50-280

INFORMATION CONCERNING HIGH DENSITY SPENT FUEL
STORAGE RACKS....INS RESPONSE TO NRC QUESTIONS
SUBMITTED BY LTR DTD 8/25/77.....

FUEL RACK ADAPTER PLATE
FIGURE 1-1

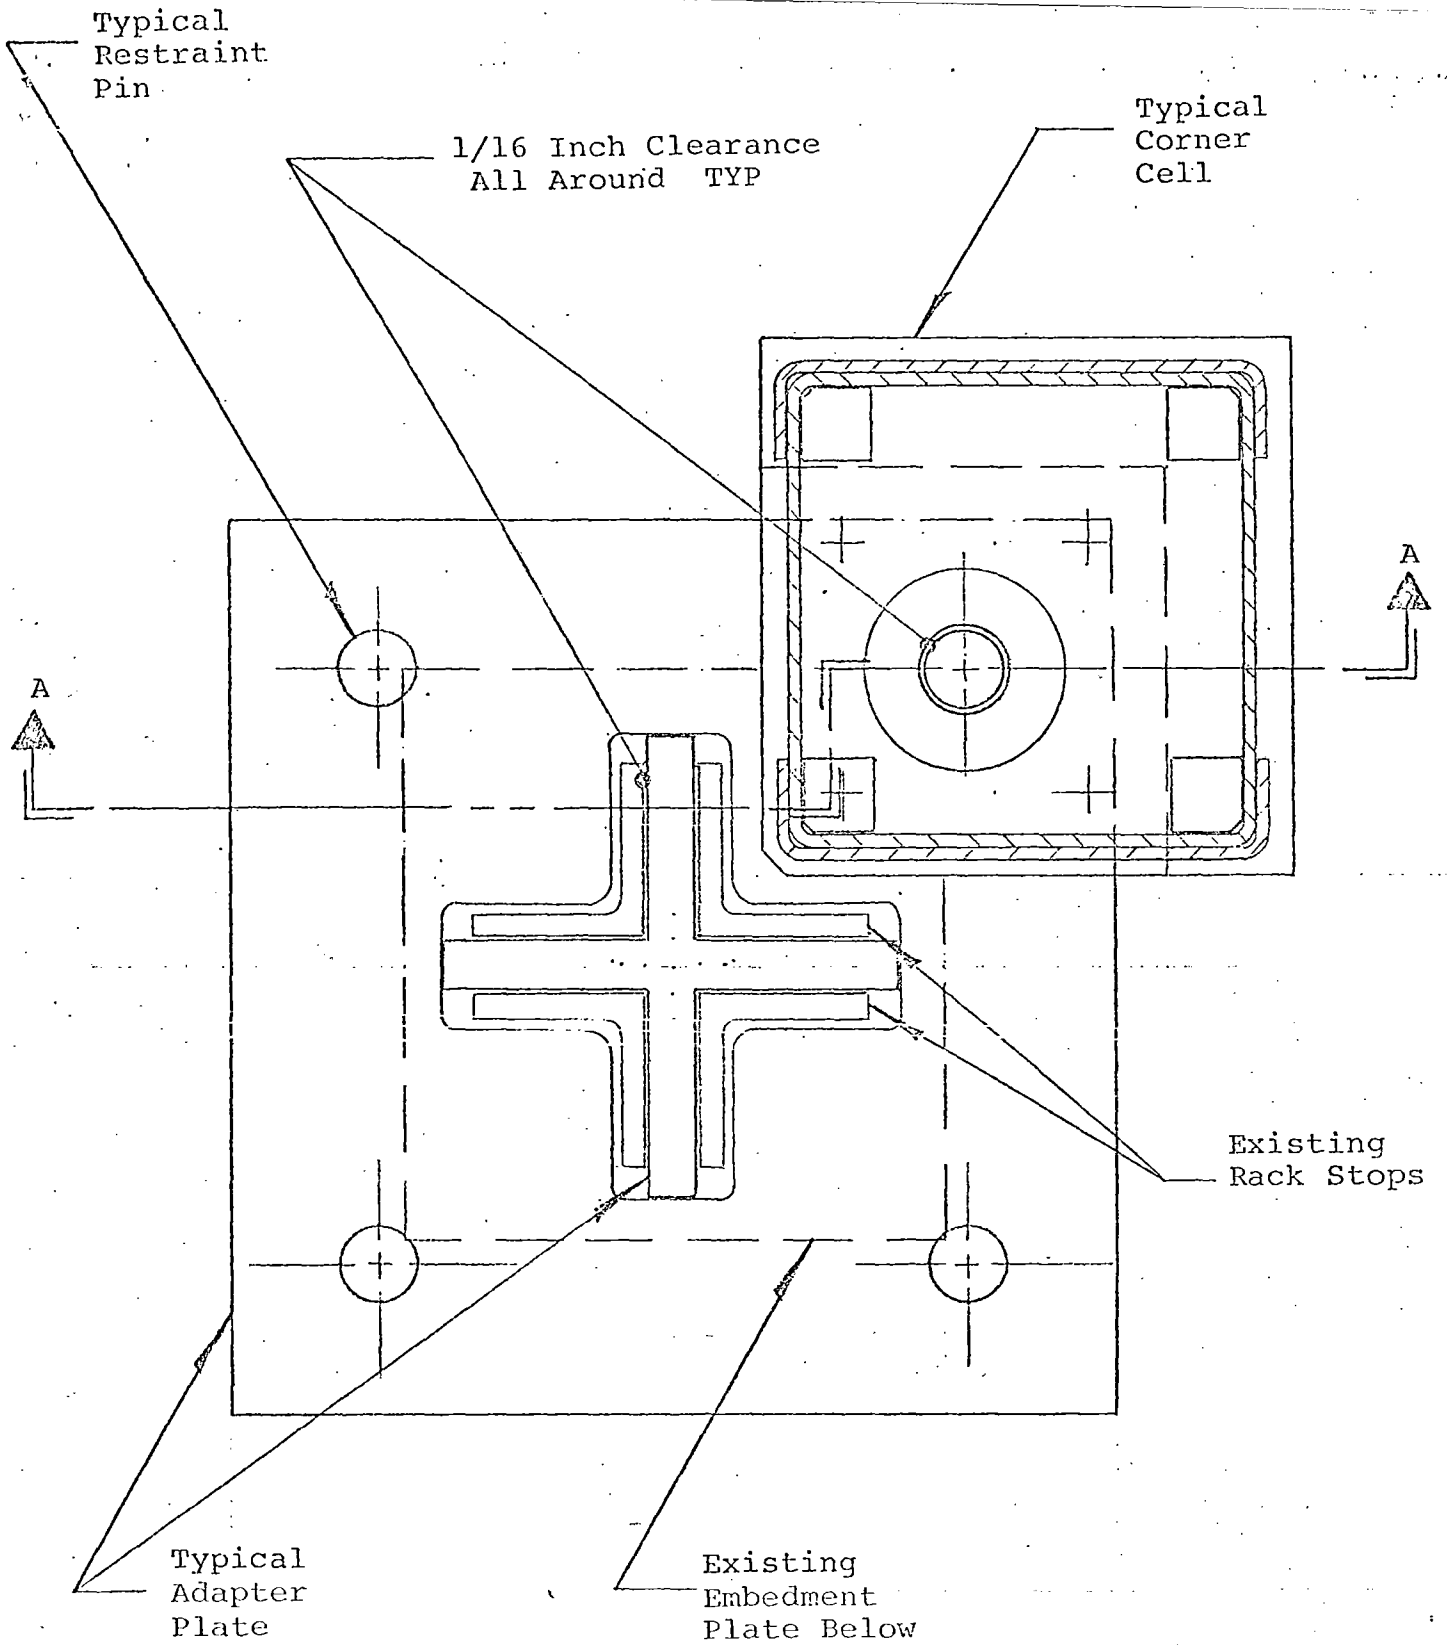
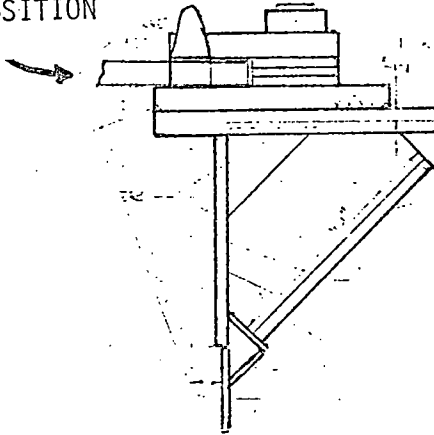
Question 1: Provide clear sketches indicating the connection between the corner storage cells and the spent fuel pool floor pads at their mating surfaces. If the corner cells simply rest on the pads, a detailed description should be provided as to how the effect of possible sliding of the rack modules and potential impact between the inner cells and the floor pads are incorporated in the design. Also discuss how the various tools and the gates in storage within the pool interact with the new rack system in a seismic environment.

Response: The corner storage cells do not just simply rest on the fuel pool floor pads. The corner cells rest on adapter plates as shown in Figures 1-1 and 1-2. The adapter plates are keyed to the existing rack stops and the corners of the fuel storage cells are keyed to the adapter plates through 1-5/8" diameter restraint pins. For installation purposes a nominal clearance of 1/16 inch is provided all around between the restraint pin hole in the corner storage cells and the restraint pin, and between the clearance cut-outs in the adapter plates and the existing rack stops. The clearance also provides sufficient allowance for thermal expansion. The horizontal seismic loads are transmitted from the rack structure to the existing rack stops at each corner of the rack through the adapter plates and pins. The racks cannot slide during any design basis seismic events.

FUEL STORAGE CELL INTERCONNECTION
FIGURE 2-1

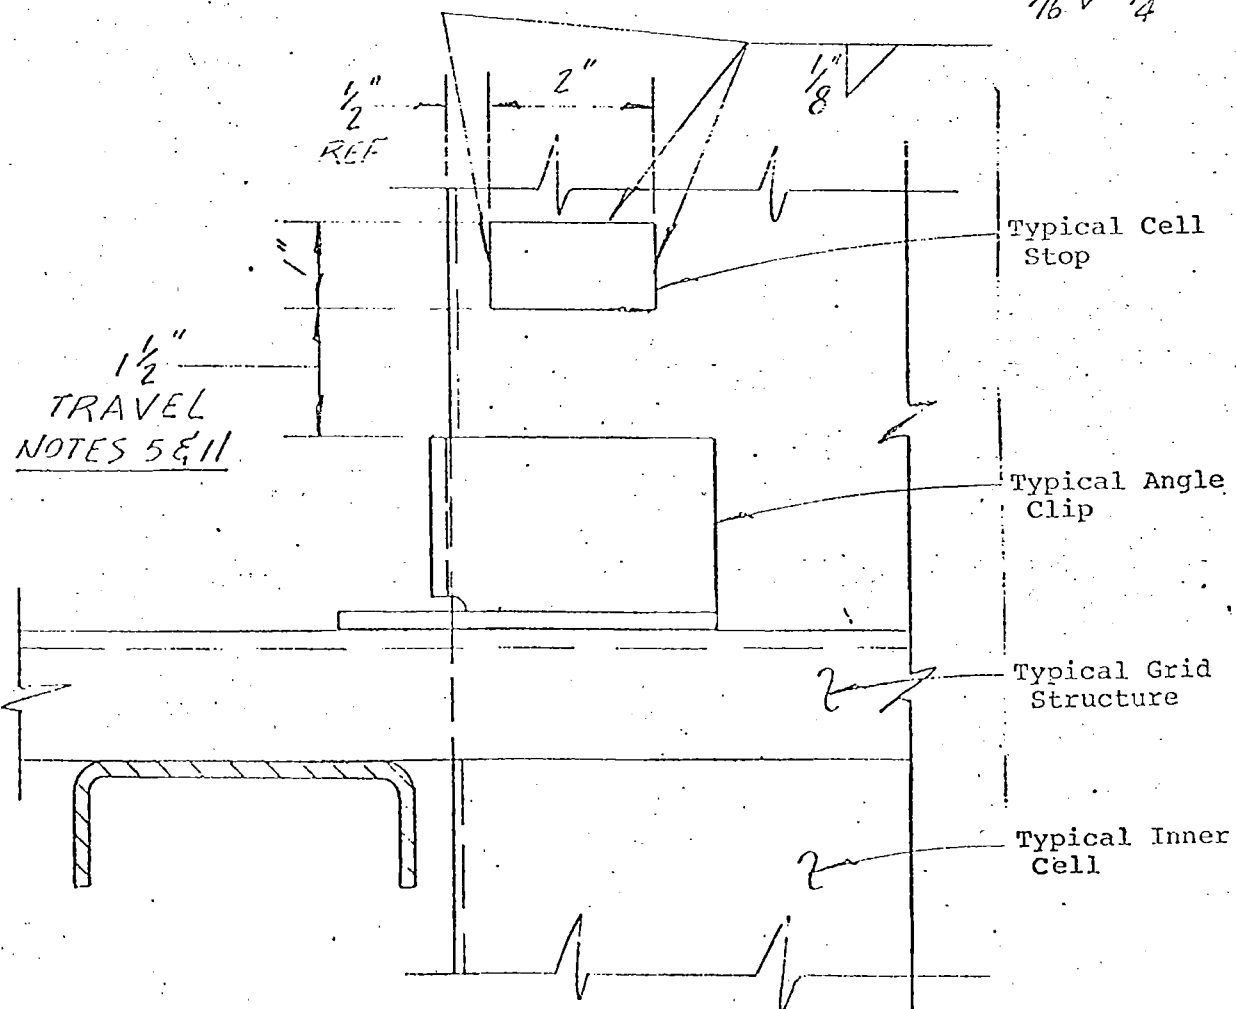
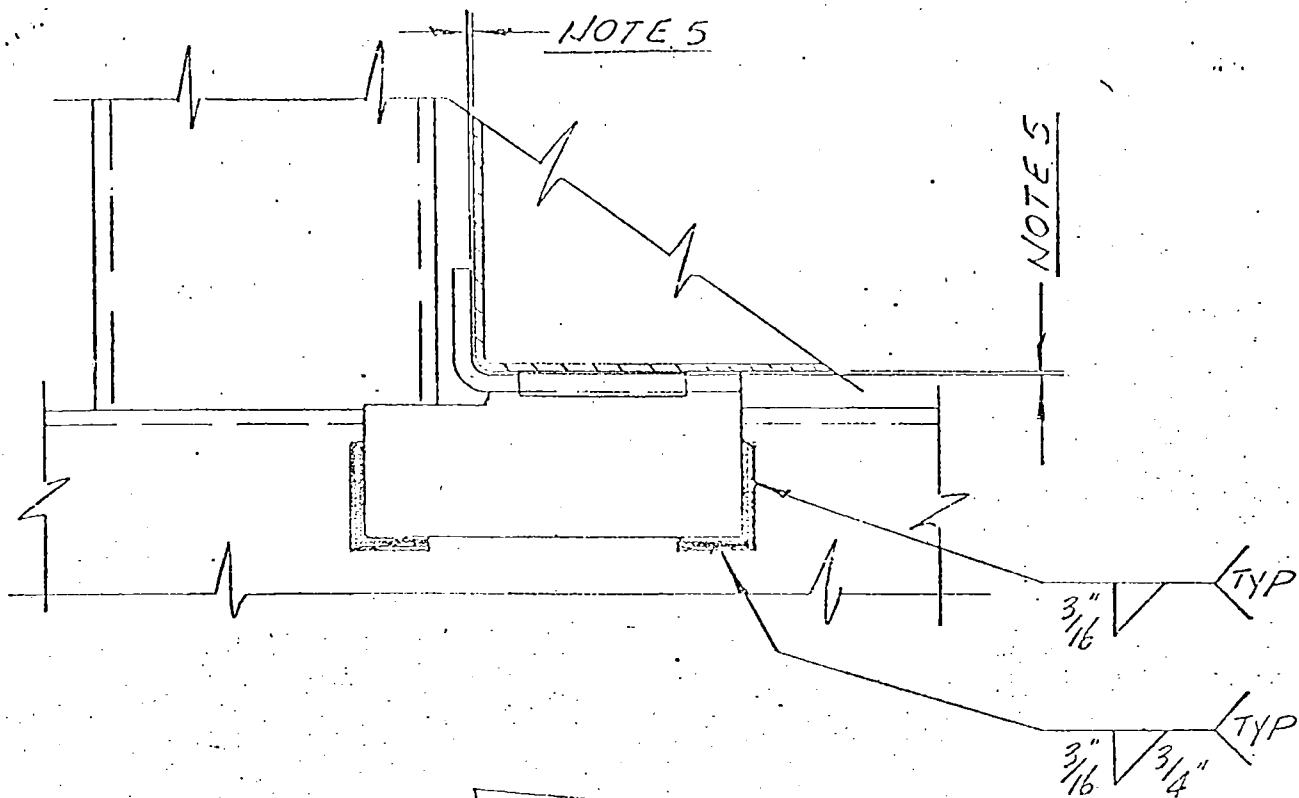
Question 2: Provide a complete description of the connection between the inner cells among each other, and among them and the corner cells indicating how the potential impact between adjacent inner cells and the corner cells are accounted for in the design. Also indicate how the stresses due to the 1" vertical deformation of the inner cells to accommodate the unevenness of the floor were accounted for by stating the specific load combinations utilized.

Response: The rack grids maintain the horizontal position of the inner cells relative to each other and the corner cells such that impact between inner cells and/or corner cells is not possible. Each grid consists of welded 4-inch by 1-1/2 inch x 3/16 inch channels forming square openings in which the inner cells are placed. The grids are welded to the top and bottom ends of the heavy wall (1/4 inch thick) corner storage cells to form the basic rack structure. Diagonal bracing welded to the corner storage cells completes the rack structure and provides the lateral and torsional rigidity to accommodate seismic and installation loads.

Figures 2-1 and 2-2 show the specific method of retaining the inner cells within the grid openings. At each grid elevation four angle clips capture the corners of each inner cell. These clips are welded to the channel members of each grid to maintain pitch and vertical plumbness. A slight clearance is provided between the clips and the cells (1/64 inch maximum for each clip) to facilitate fabrication and to permit vertical movement of the inner cells. Such vertical movement does not introduce any stresses/deformations in the rack structure or the inner storage cells since each inner cell can move freely past the grid retaining clips to sit directly on the pool floor. The design permits the vertical loads for each inner cell to be transmitted to the pool floor. It is necessary to limit the vertical travel of the inner storage cells to prevent (1) removal of a cell during fuel handling operations (e.g. stuck fuel assembly load case) and (2) a cell dropping out of the rack during rack installation/removal. Mechanical stops welded to each inner cell limit the total vertical travel to about 2 inches (+ 1 inch). These stops will support the weight of the fuel cell plus a fuel assembly if necessary.
